TECHNICAL SERVICE BULLETIN

7.3L - Illuminated MIL With Misfire Or Lack Of Power And DTCs P0300, P0316, And/Or P0301-P0304 - Built On Or Before 28-Sep-2020

20-2370
09 November
2020

Ford 2020 F-53 Motorhome Chassis	Engine: 7.3L
--	--------------

Figure 1

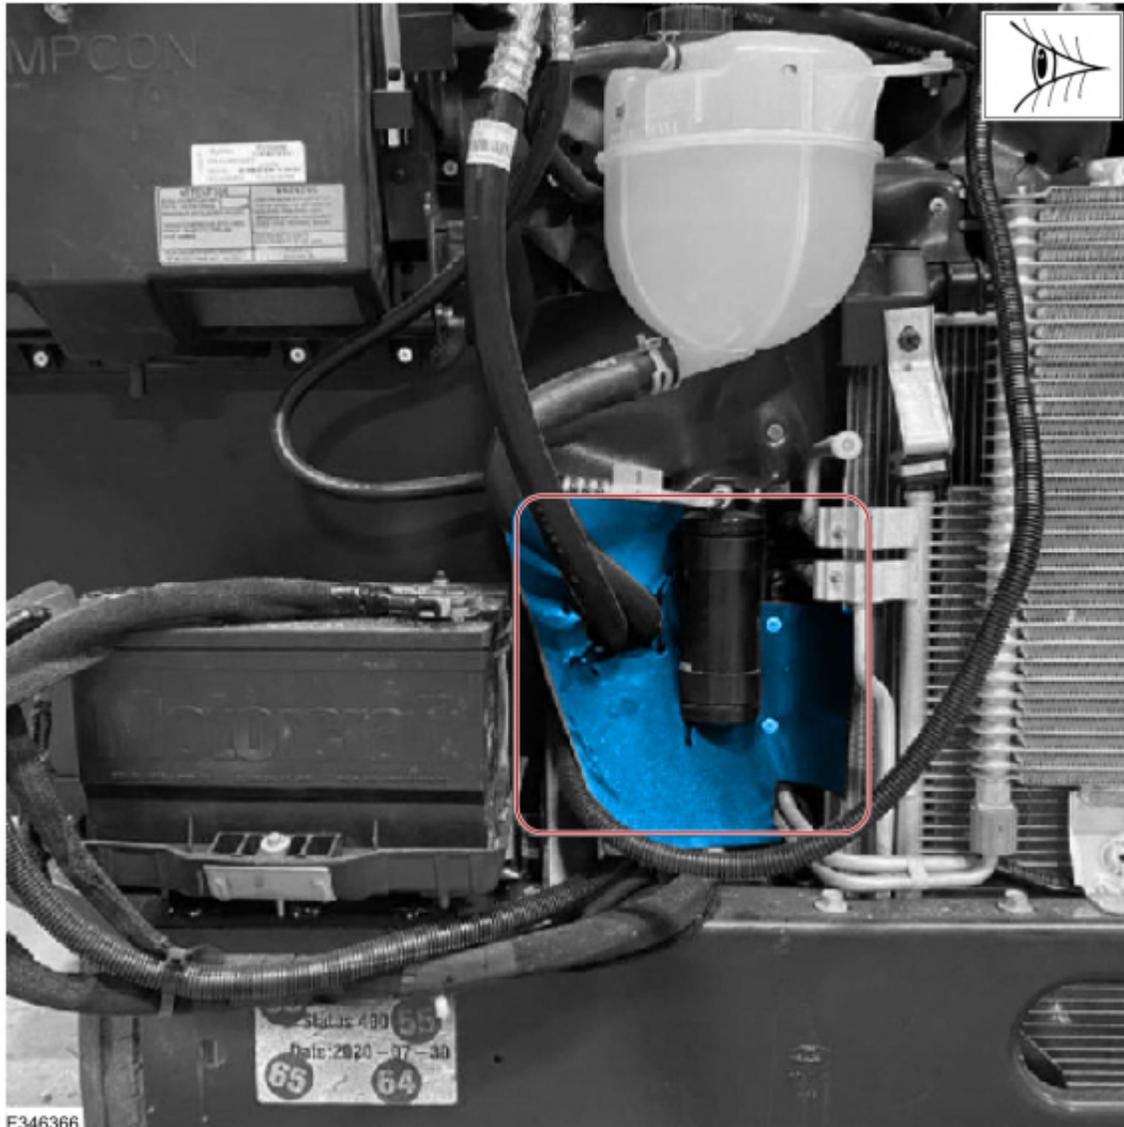
1. Locate the passenger side engine compartment baffle. Does the baffle completely cover the area between the radiator assembly and the battery tray as shown in Figure 1?

(1). Yes - proceed to Step 2.

(2). No - this article does not apply. Refer to the Powertrain Control Emission Diagnosis Manual (PC/ED) for normal diagnosis.

Figure 2

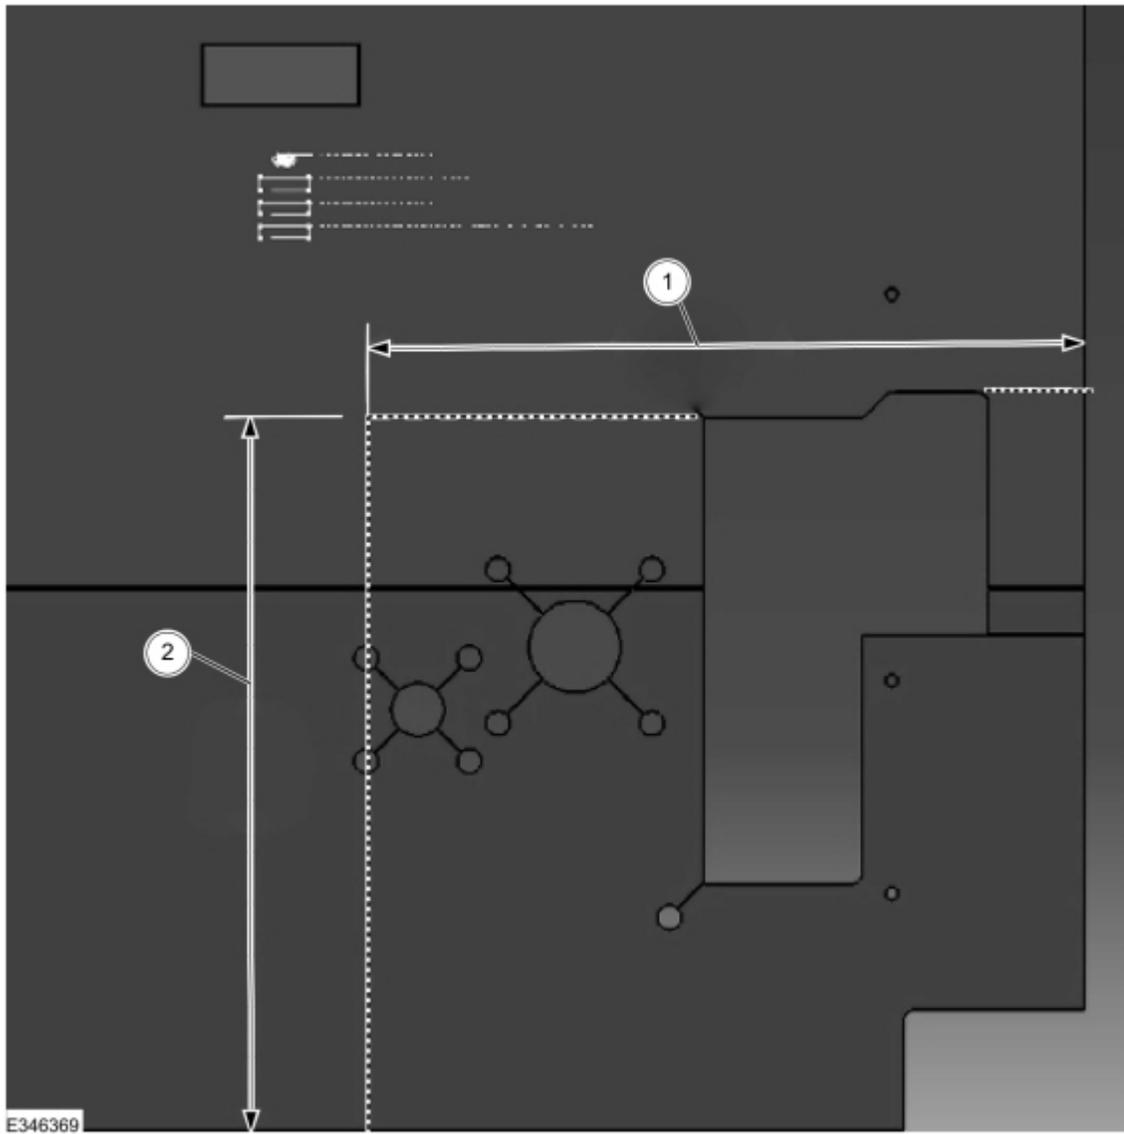
2. Trim the engine cooling baffle on the passenger side using a suitable cutting tool. (Figures 2-4)

Item	Description
1	297 mm
2	295 mm
